STAFF RECOMMENDATION
1310 Seventh Avenue North
October 21, 2015

Application: Demolition—Outbuilding; New construction—infill
District: Germantown Historic Preservation Zoning Overlay
Council District: 19
Map and Parcel Number: 08209003100
Applicant: John Root, Architect
Project Lead: Melissa Baldock, melissa.baldock@nashville.gov

SITE PLAN

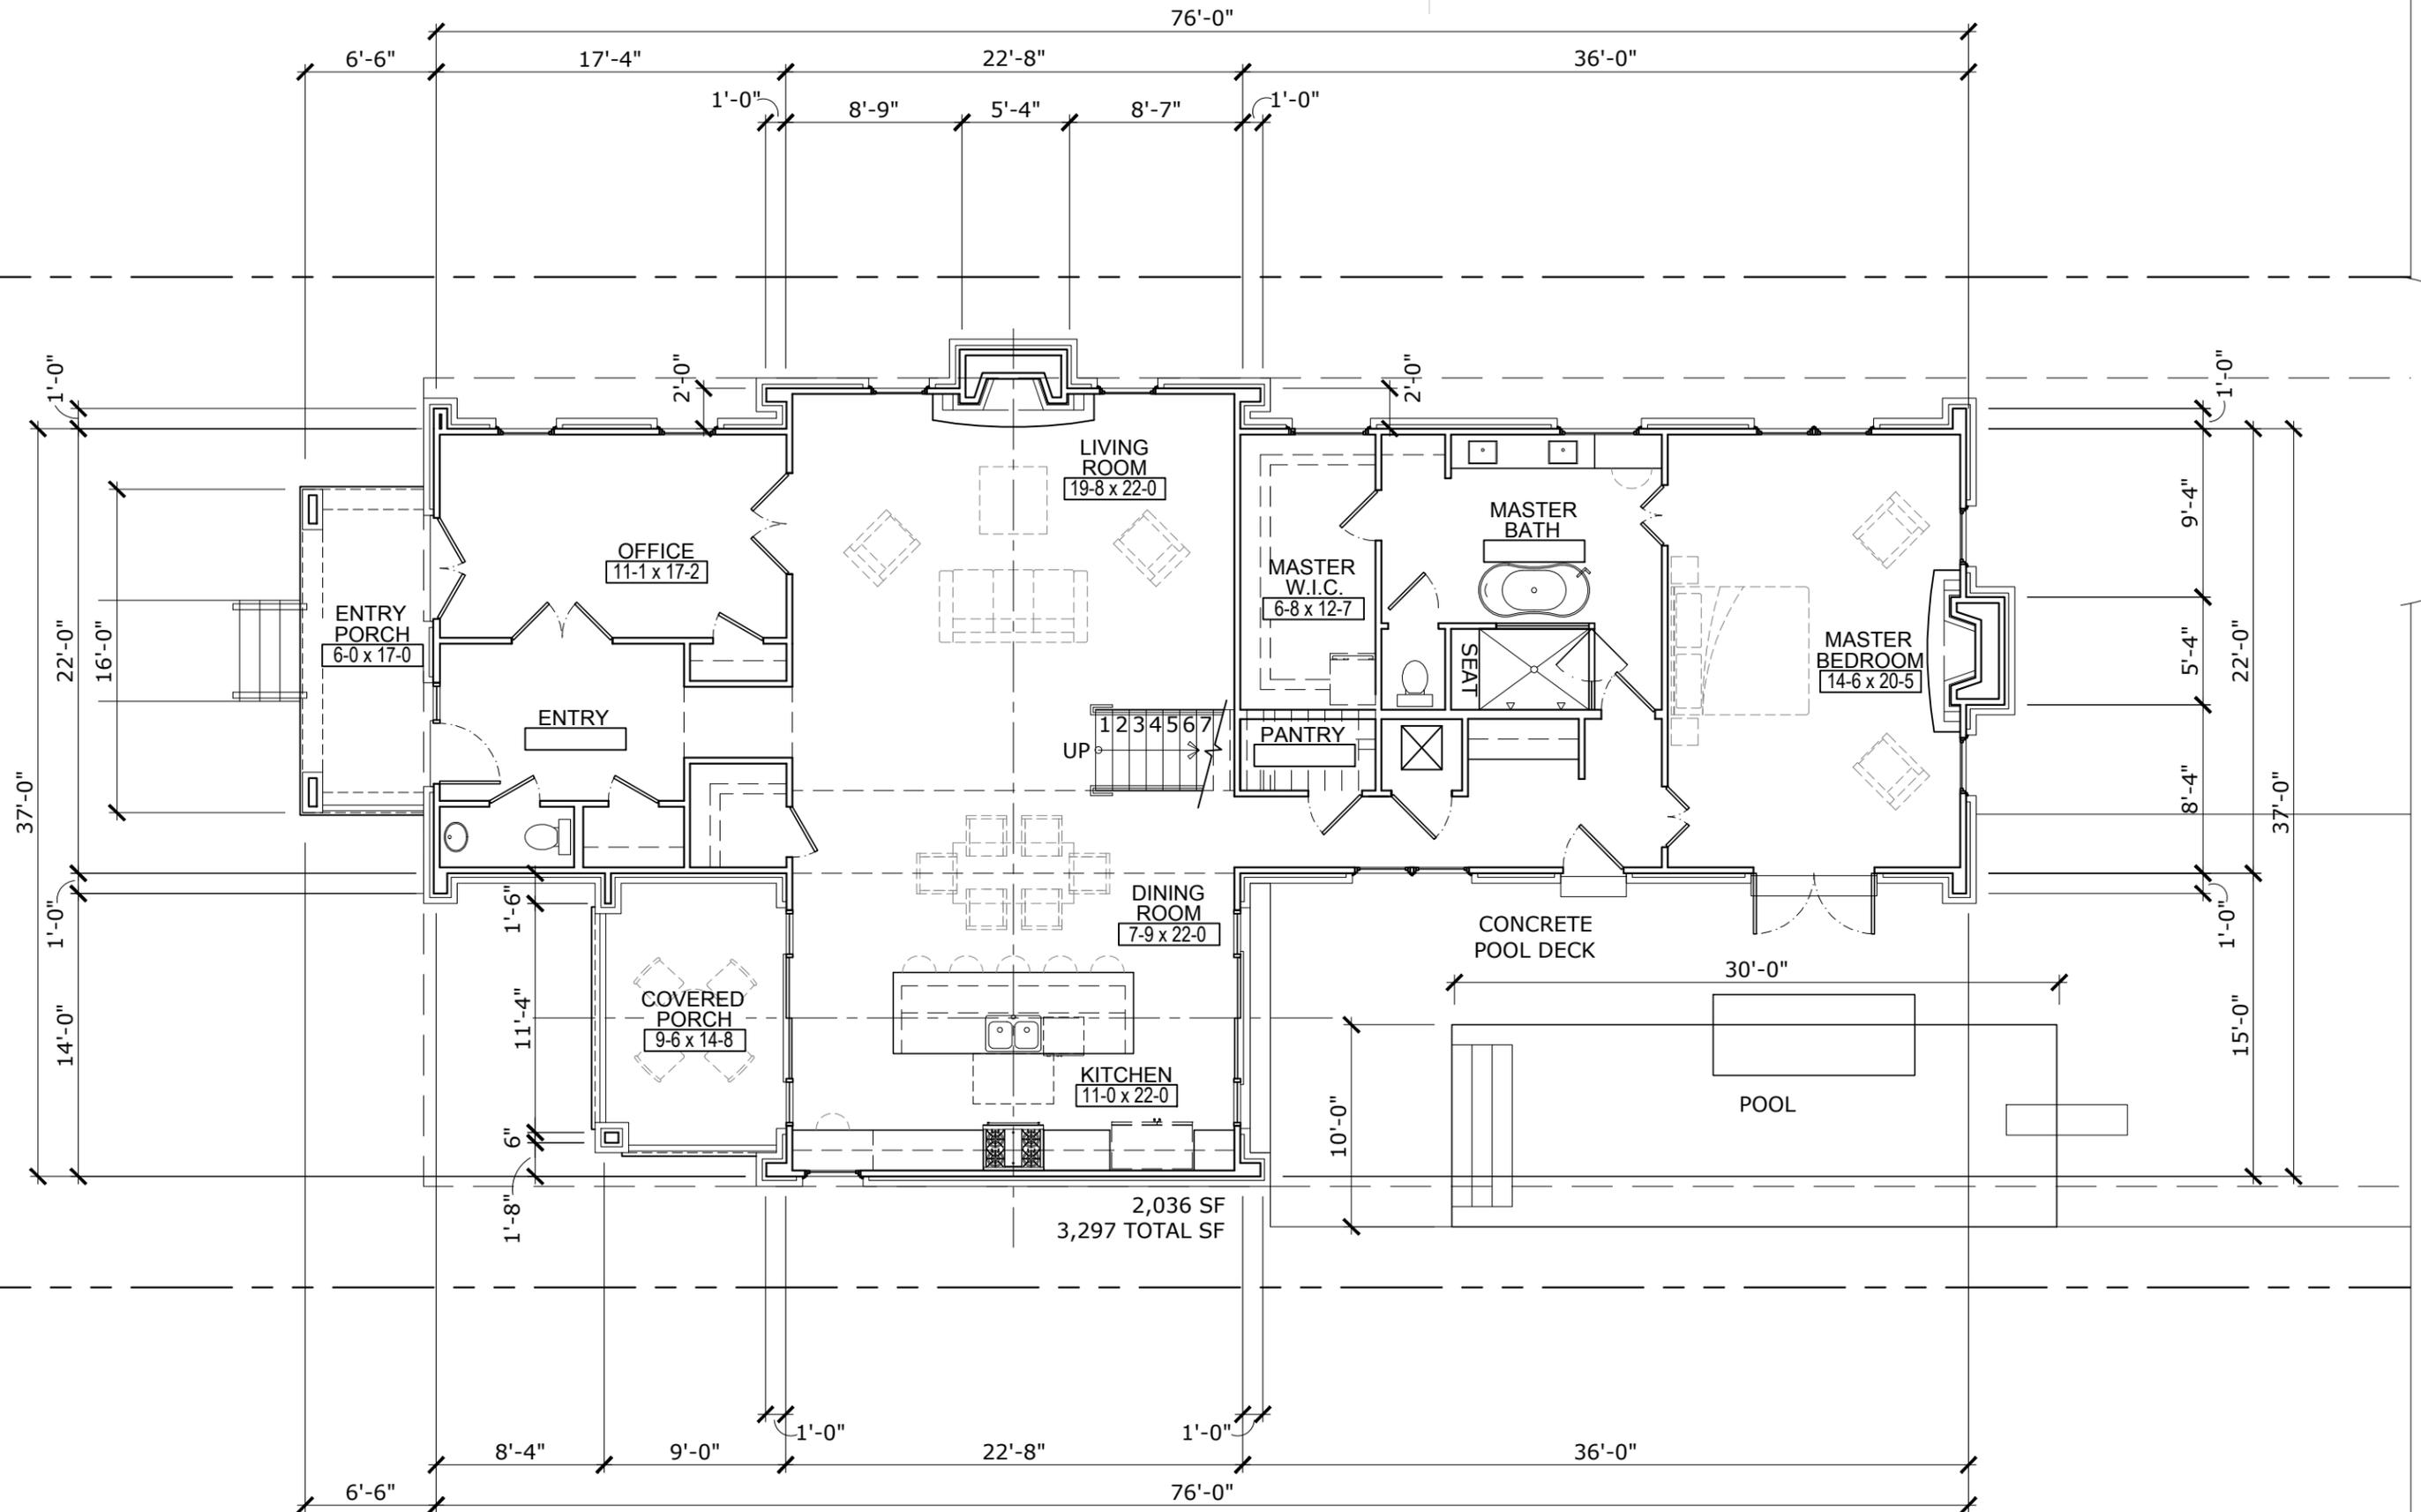
Utilities/Mechanical. No location for the mechanicals and utilities were indicated on the site plan, and staff recommends that they be place at the rear, or on a side façade behind the midpoint of the house.

Fences, walls, and other appurtenances. The site plan indicates that a six foot (6’) wood privacy fence will be installed from the midpoint of the infill to fence in the rear yard. Staff finds this to be appropriate. A four foot tall (4’) aluminum fence will be installed in the rear yard around the pool, and within the perimeter of the six foot (6’) privacy fence. If approved, Staff recommends approval of the pool fence design prior to purchase and installation. Staff also recommends approval of the patio and pool deck pavers and any other site features to ensure that they comply with Section 5.1 of the design guidelines.

WEST ELEVATION

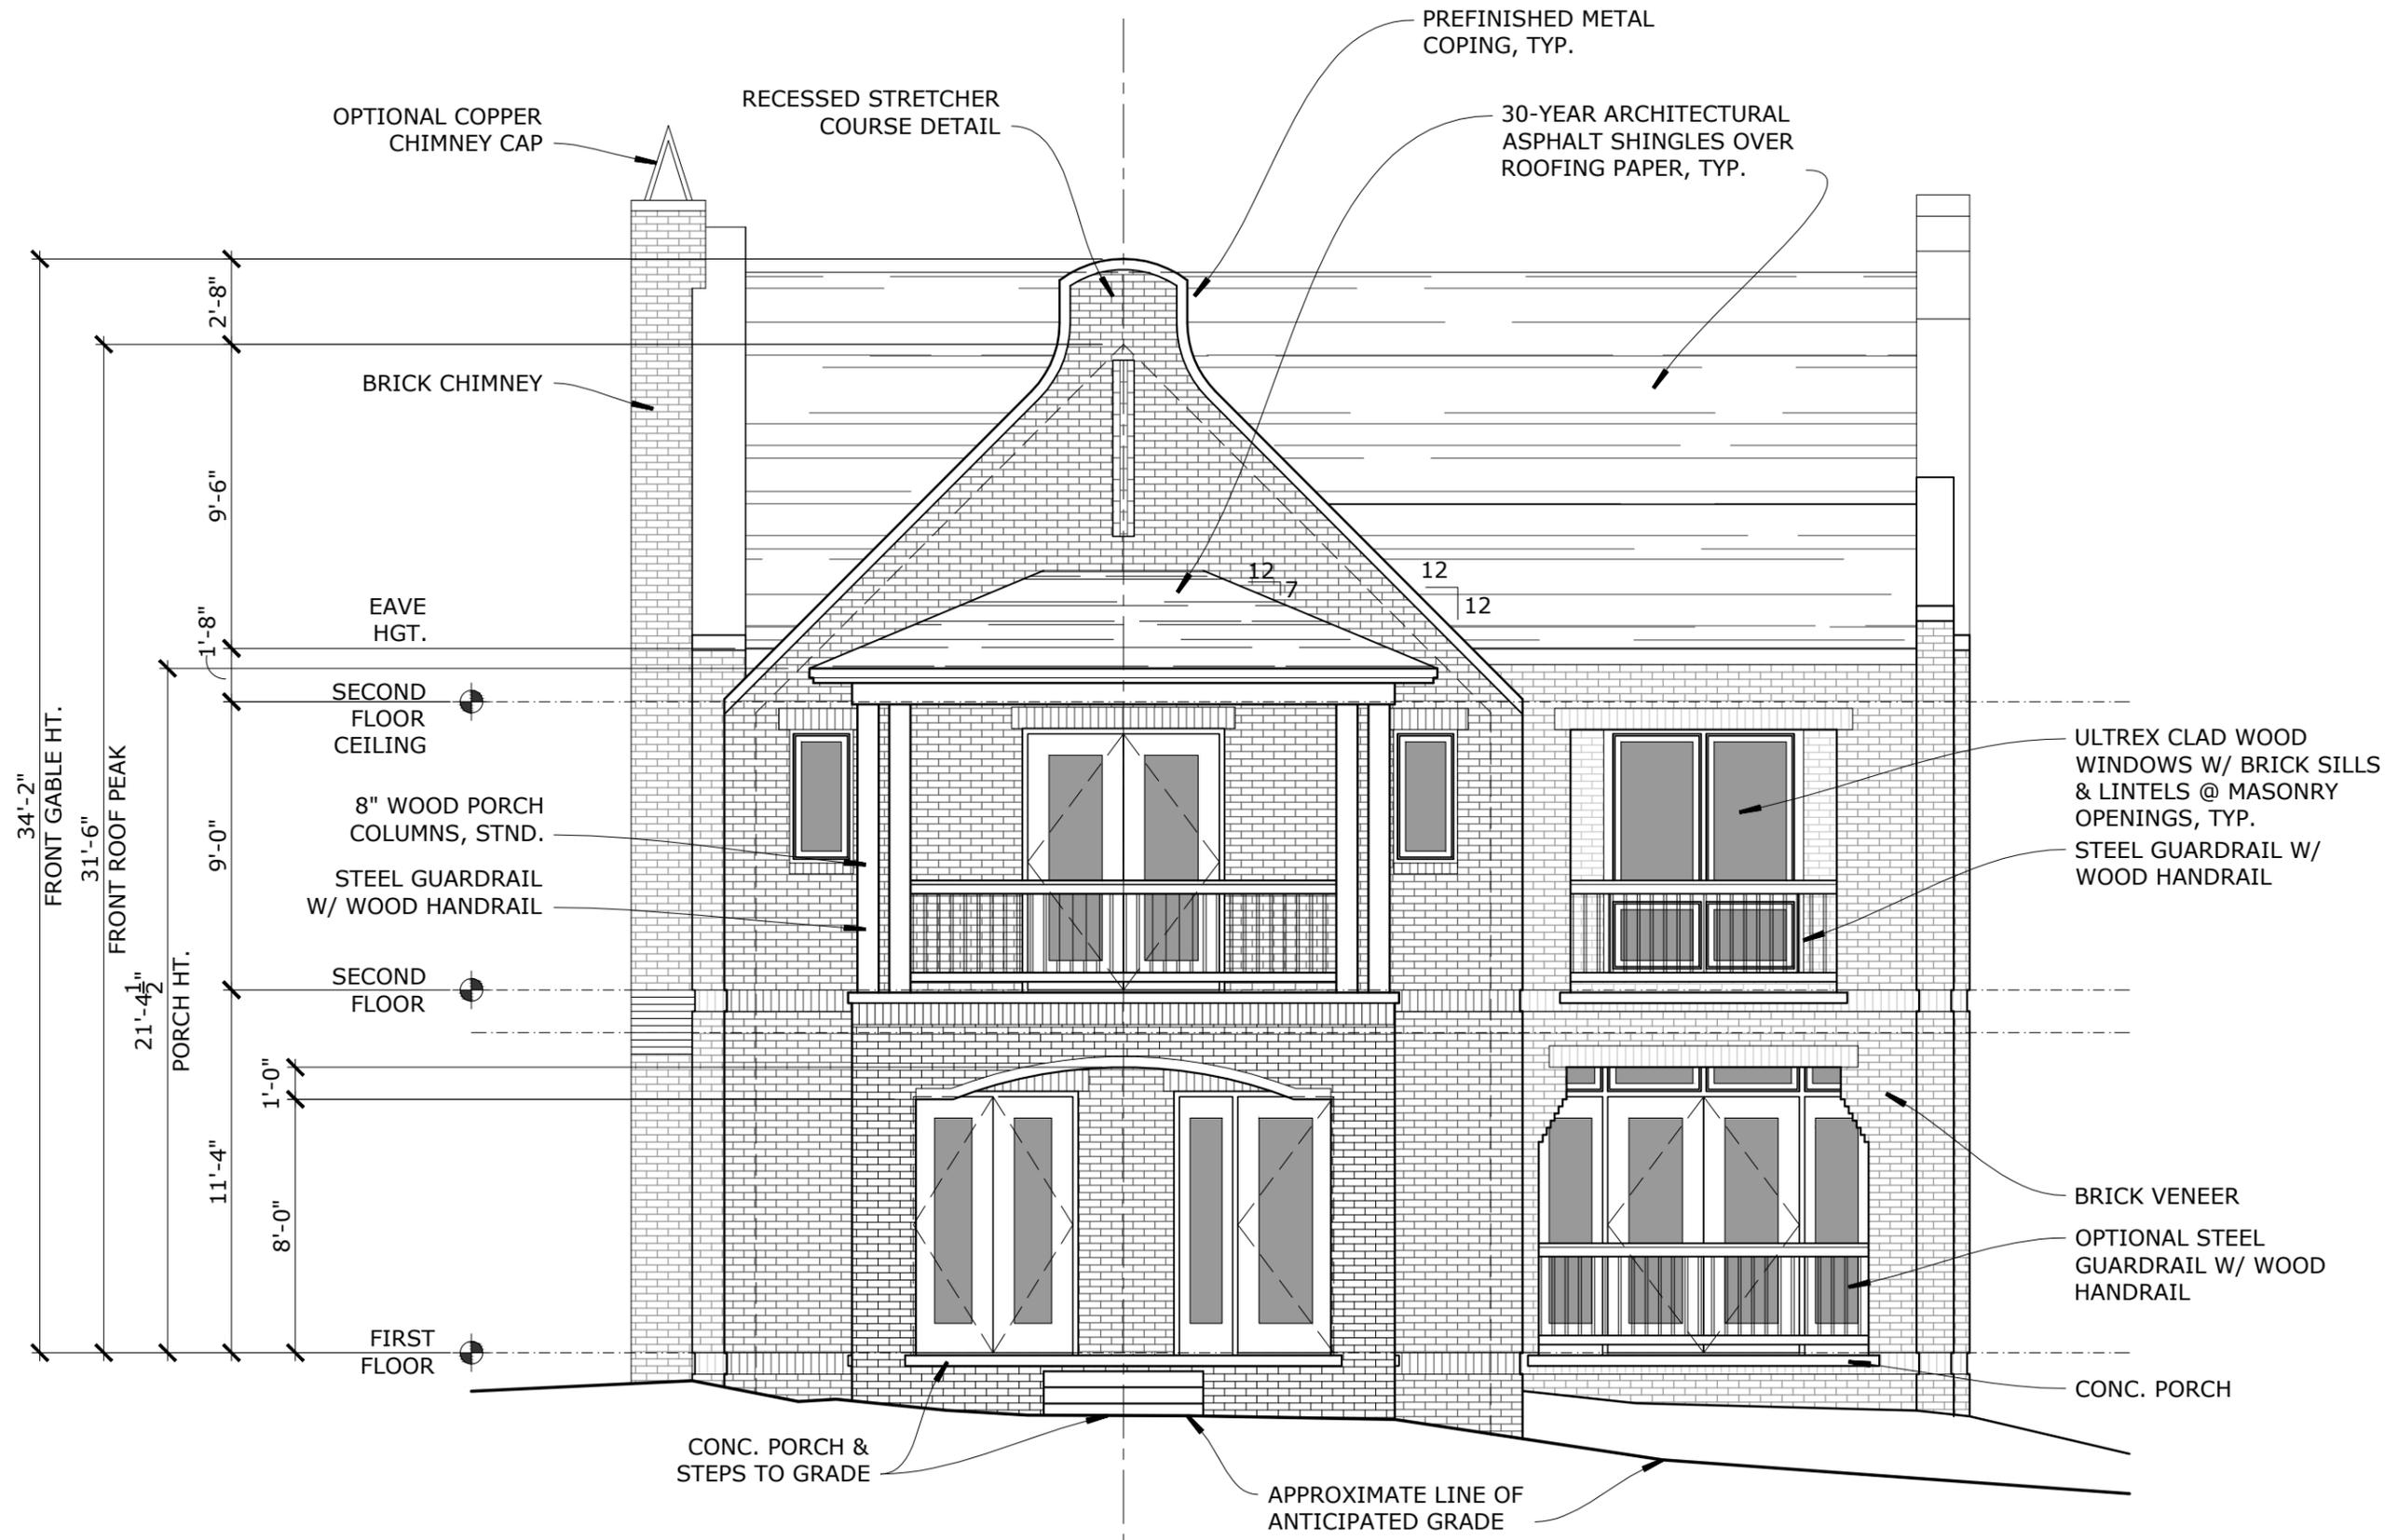
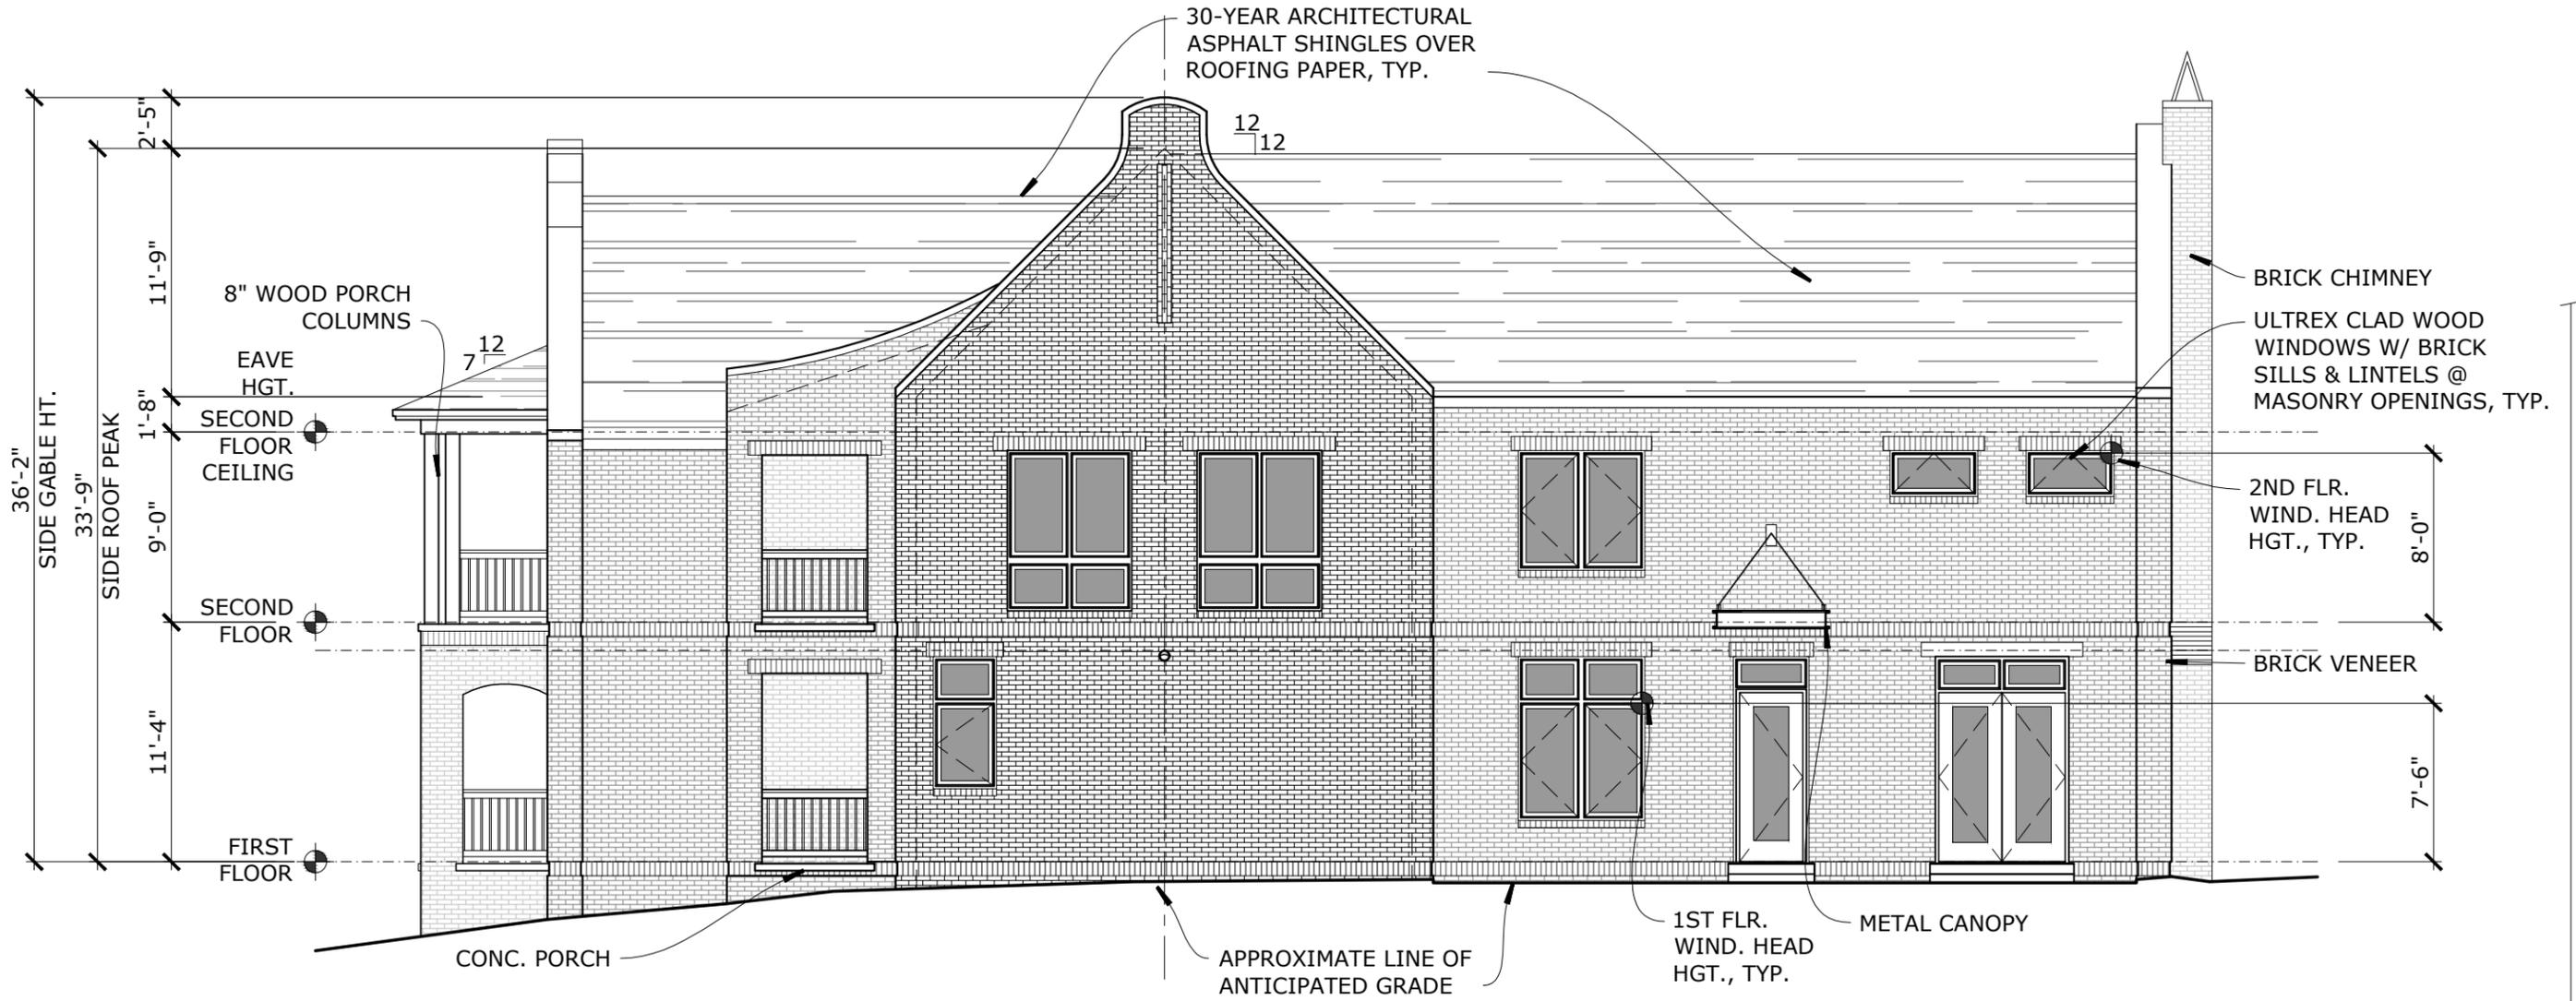
The infill design includes two covered second story front porches. The second story porch over the main front porch has a hipped roof with a 7/12 pitch. Its columns lack caps and bases. Staff finds that the orientation meets Section 2.2.2. of the design guidelines.

The second story front porch over the secondary entry and porch is inset within the roof of the house. Staff finds that both second-story porches are inappropriate. Two-story covered porches are not a feature found historically in the Germantown neighborhood and accentuate height. With the exception of the co-housing project at the corner of Taylor Street and Fifth Avenue North, the Commission has not approved other requests for two-story porches. The Commission found the co-housing project to be appropriate because of its location next to Werthan Bag, which is of a much larger scale than the rest of the district. One option would be to turn the railing of the principle, projecting porch into a parapet wall and remove the second-story cover. This would still allow for usable space on the second story but without accentuating the height.

Porches and Entrances. The primary and secondary first floor porches on the infill are appropriately deep at six feet, six inches (6'6") and ten feet (10'), respectively. However, staff finds that the two front second-story porches do not meet the design guidelines, which state "The height of porch roofs shall be compatible, by not contrasting greatly, with those of surrounding historic buildings." The porch roofs are approximately twenty-six feet (26') tall, which is significantly taller than the historic roofs on this block, all of which are one-story in height. Two-story porches are not a common historic feature for

The main porch roof will be hipped at the second level with a 7/12 pitch. A second-story porch roof is not appropriate for single-family infill in Germantown, as they are not found historically on single-family houses. Staff therefore finds that the porch roof does not meet Section 2.7 of the design guidelines

Recommendation Summary Staff recommends disapproval of the project, finding that the infill’s two-story porches on the front façade do not meet Sections 2.2.2., 2.2.3., 2.6., and 2.7. of the *Germantown Historic Preservation Overlay: Handbook and Design Guidelines*.

Staff does not recommend approval with conditions because removal of the second-story porches would likely require a complete redesign of the infill.
